Municipal Code Change

CITY COUNCIL – November 7, 2023

Municipal Code Change

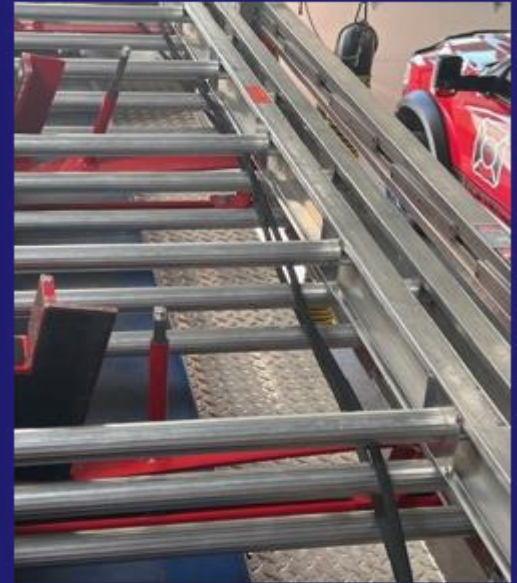
Current municipal code section 12-16-50 (4) b states that landscaping shall be maintained so there is eight (8) feet of overhead clearance from any roadway.

International Fire Code 2021 states that all fire apparatus access roads shall have an unobstructed vertical clearance of not less than thirteen (13) feet six (6) inches.

We are asking to change the municipal code to eight (8) feet over sidewalks and fourteen (14) feet over streets.
